CITY PLAN COMMISSION STAFF REPORT

Oak Park Townhomes

Item	Case	Request
#5.1	CPC-2020-00116	Area Plan Amendment
#5.2	CPC-2020-00091	Rezoning with plan
#5.3	CPC-2020-00159	PIEA Plan

1 SITE PLAN
SCALE: 1"=30'-0"

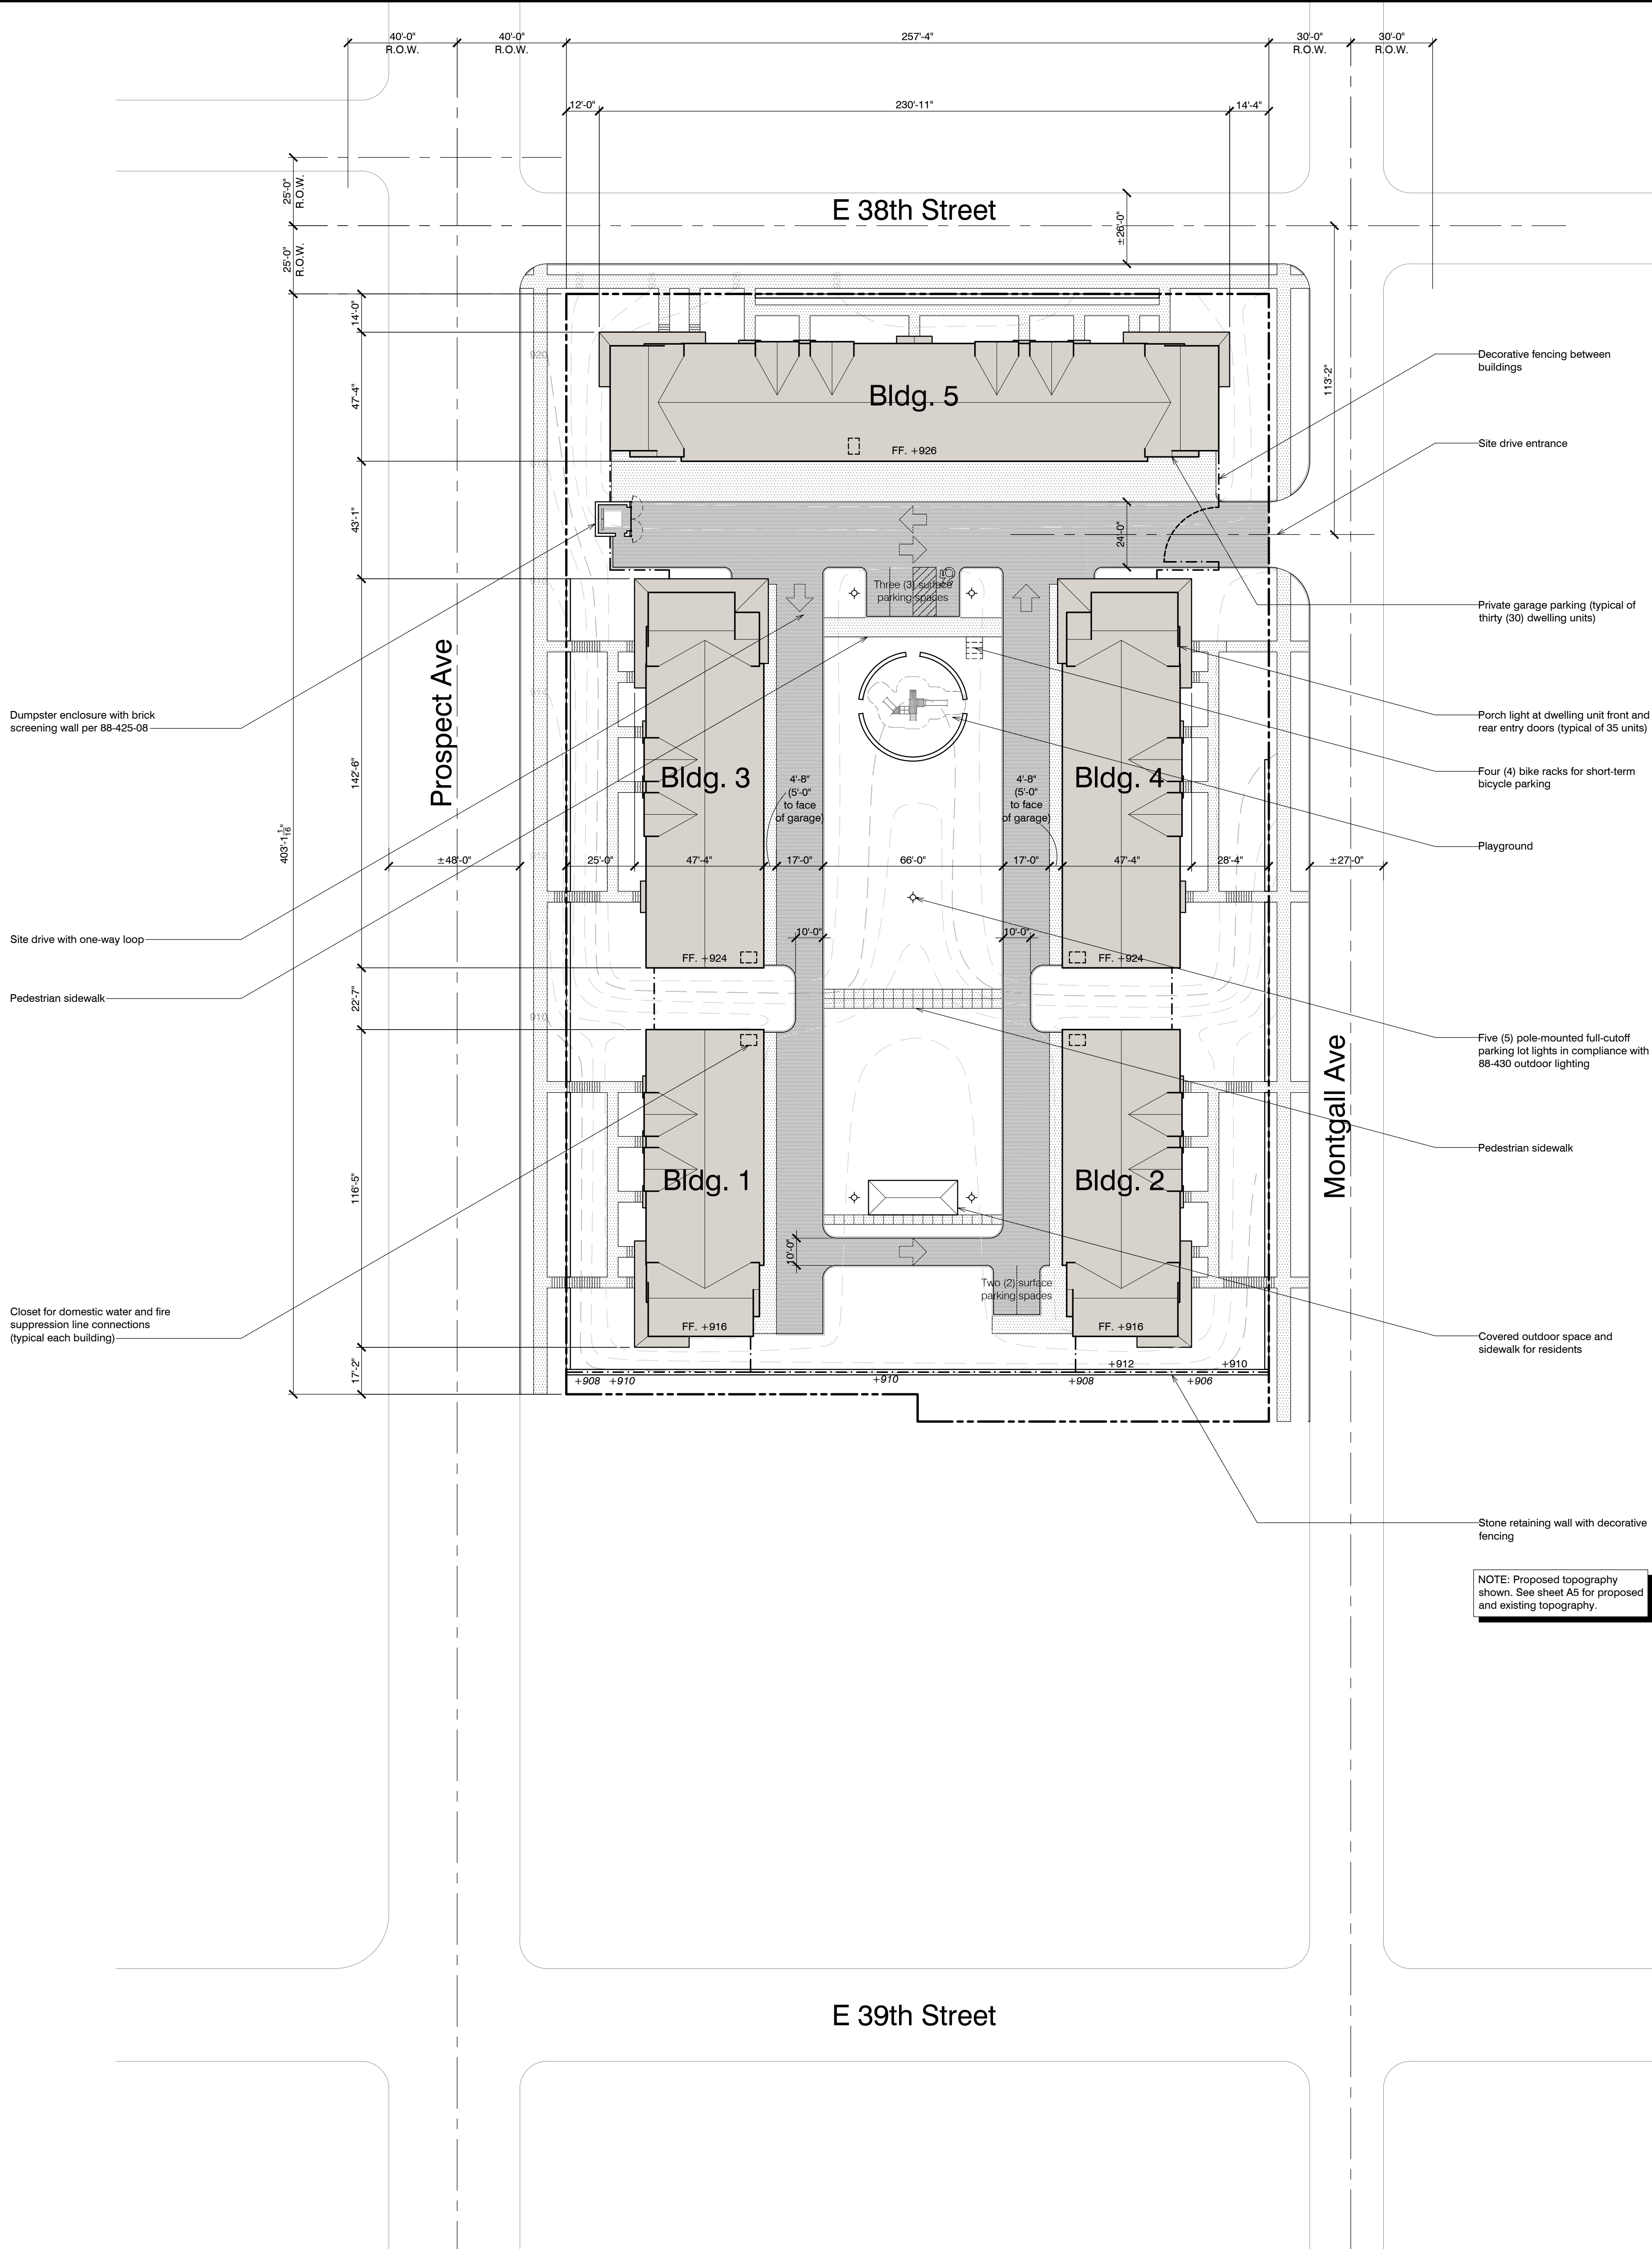
The submitted plans shows two story townhomes constructed of brick, with horizontal lapping accented with painted wood siding and asphalt shingles. The plan did not include architectural building elevations calling out specific materials. The plan also shows a gate at the main driveway. Staff recommends that the gate be recessed a minimum of 20' from the property line to allow for a car to be clear of the sidewalk.

Due to the grade change, the pedestrian walkways have stairs that connect to internal sidewalks that eventually connect to the public sidewalks. Staff recommends that additional pedestrian access be provided on Prospect Avenue and Montgall Avenue.

The plan shows 35 parking spaces which is the exact number of spaces required by the Zoning and Development Code. 30 spaces are within garages and there are 5 spaces outside. Staff is concerned with parking within the courtyard as it may impede movement.

- f. Provide phasing information on the face of the plan.
- g. Revise plans to provide direct access from the public street to the courtyard from Prospect Avenue and Montgall Avenue.

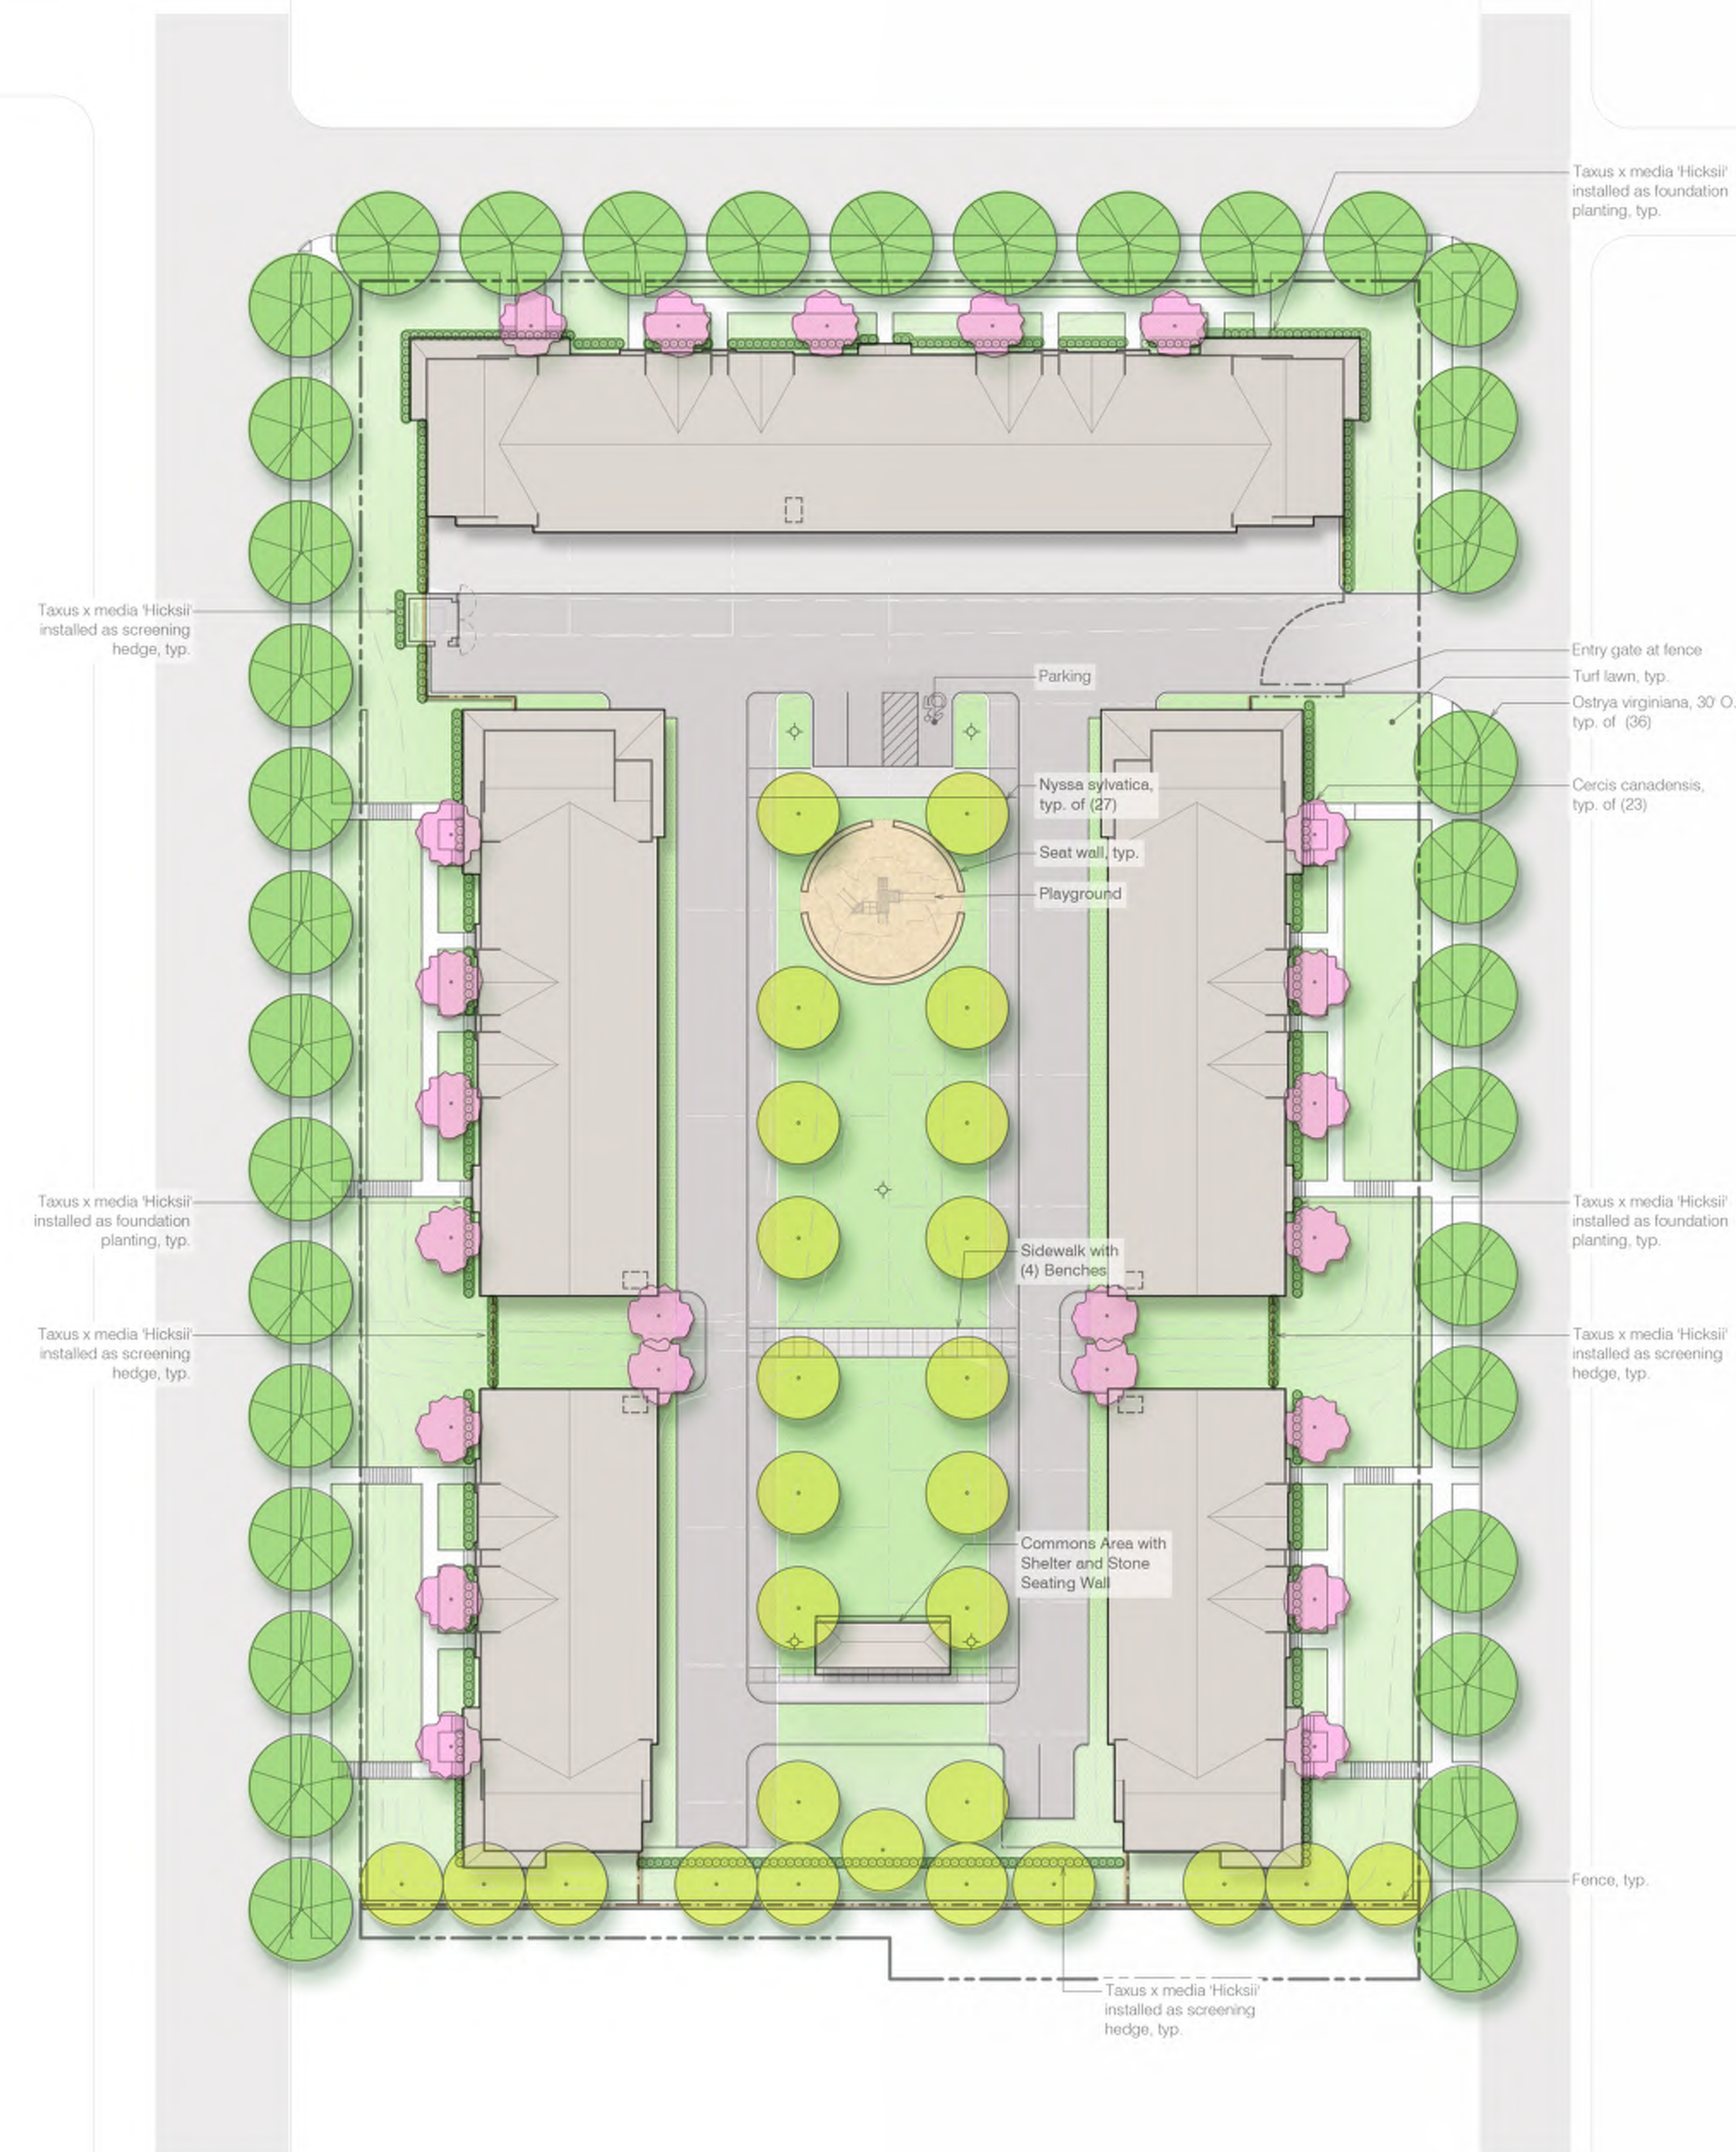
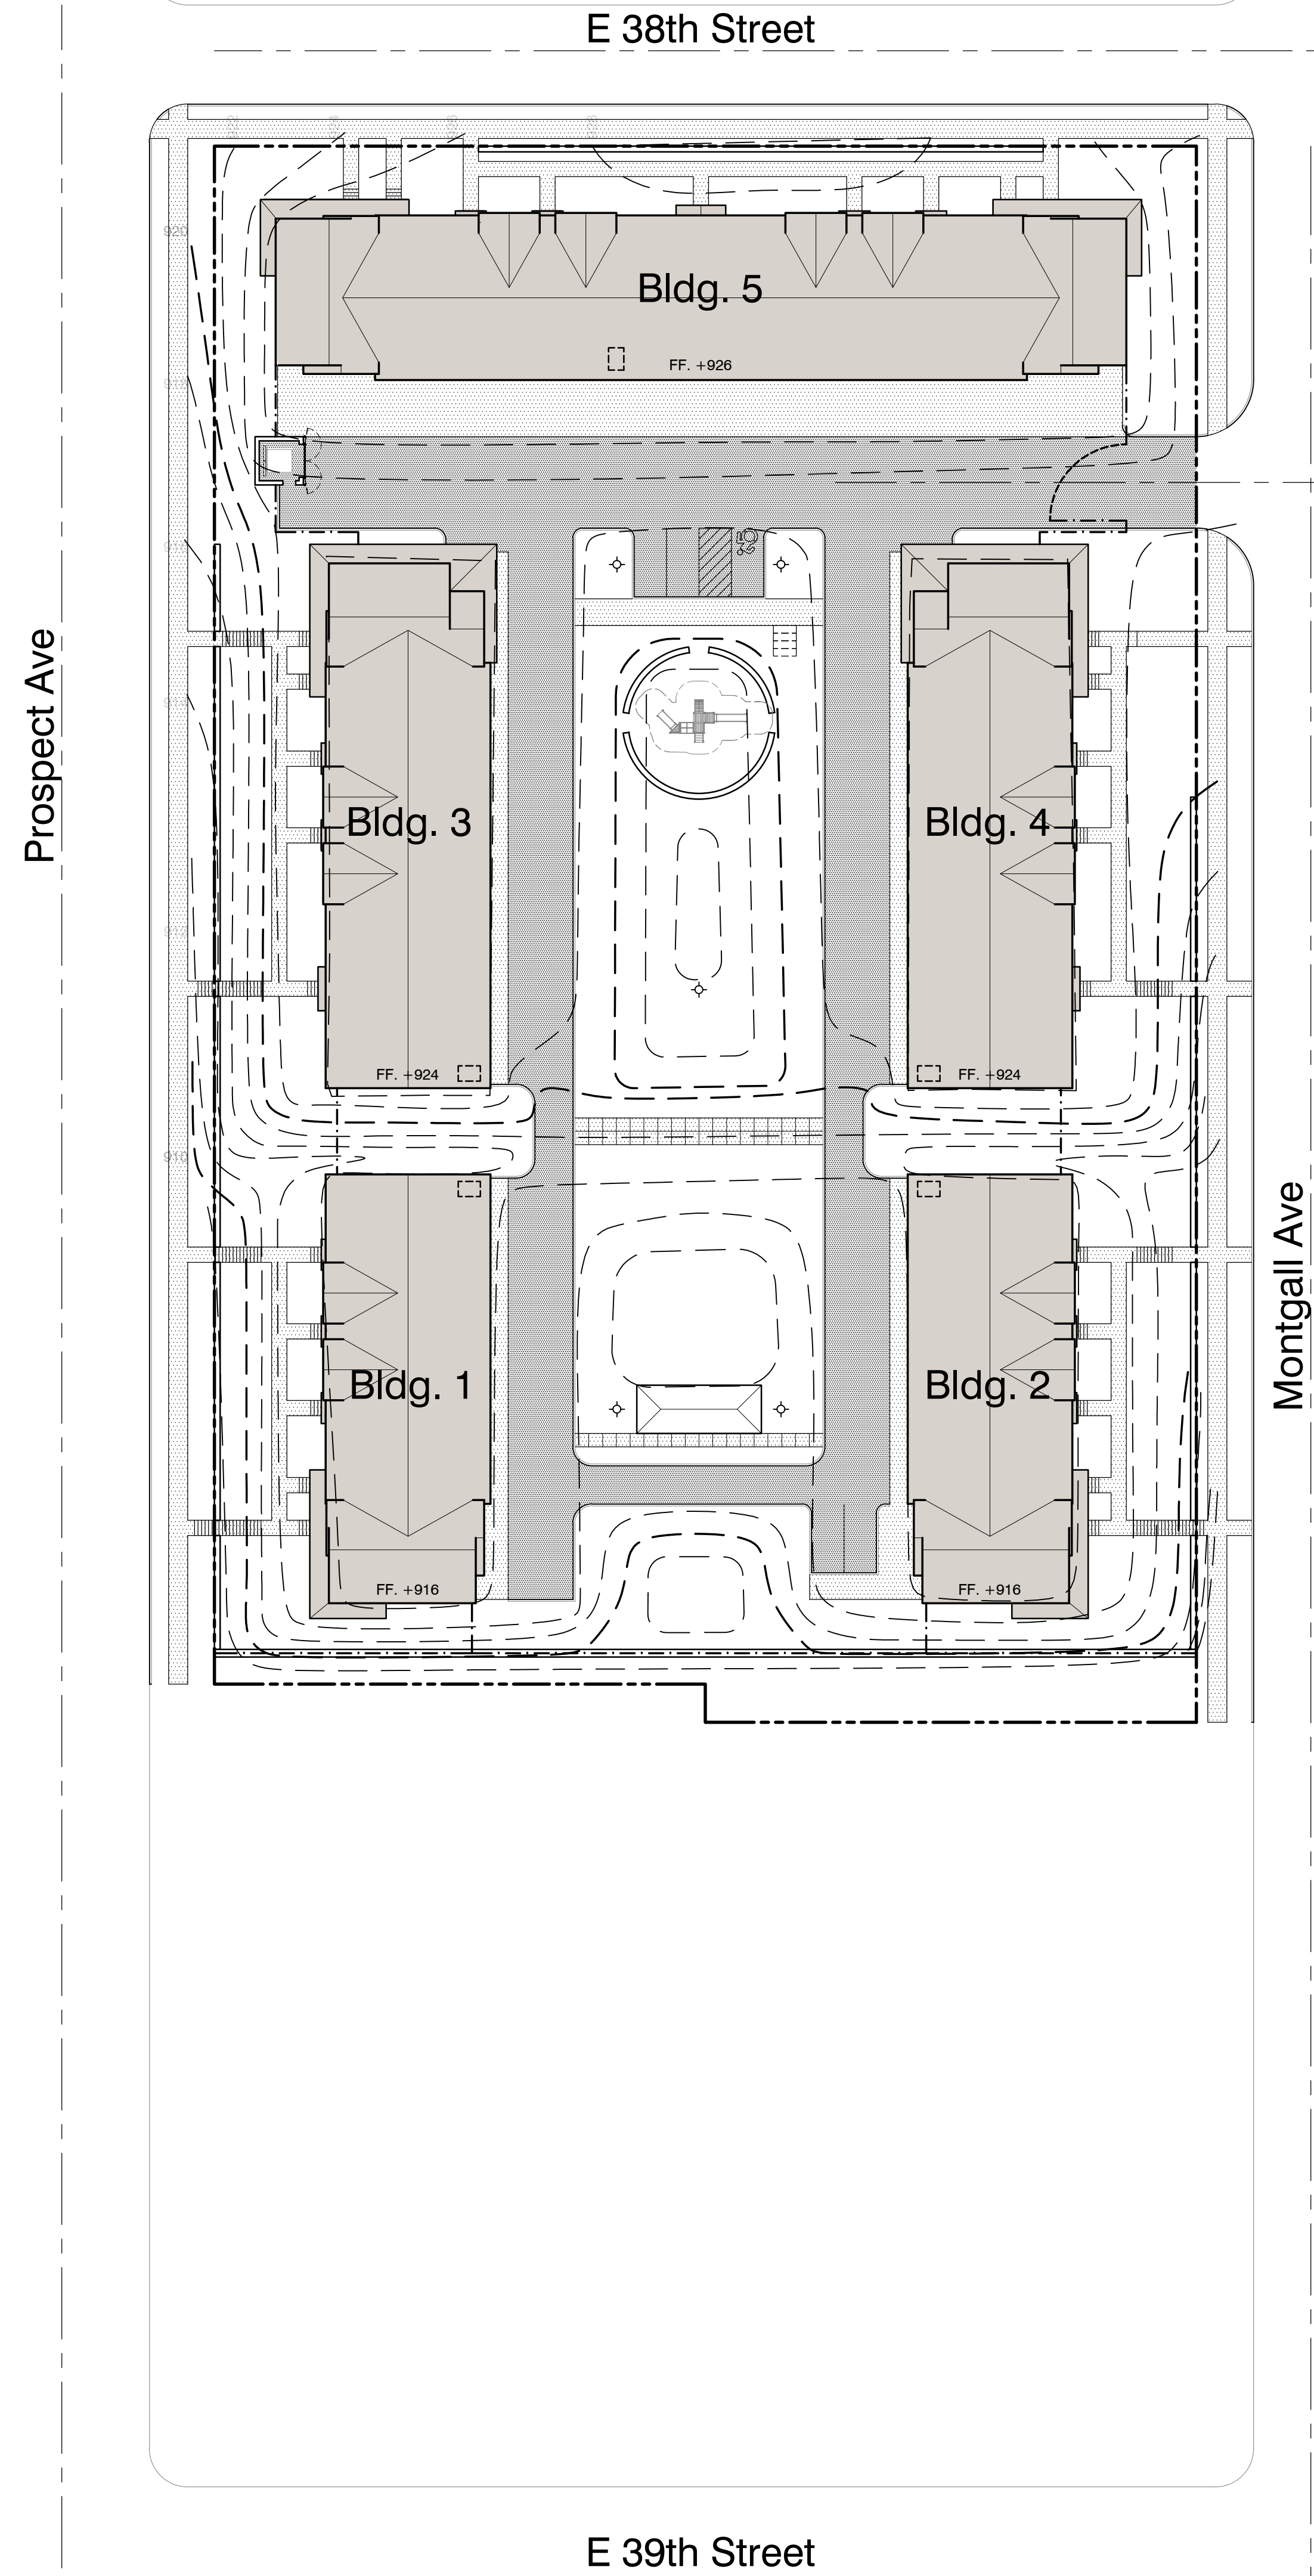
A preliminary landscape plan has been prepared by the applicant indicating street trees and shrubs along public streets per the requirements of the Zoning and Development code. Staff recommends that additional landscaping and berms where possible be provided to provide additional buffer screening around the rear of the dumpster enclosure. The final landscaping plan shall be reviewed with the final UR plan and shall include a detailed foundation planting scheme for each building.

- j. Incorporate more brick and where siding is used, use a cementitious low-maintenance materials.
- k. Show landscaping in compliance with general landscaping requirements of 88-425-04. Revise Plans and Resubmit
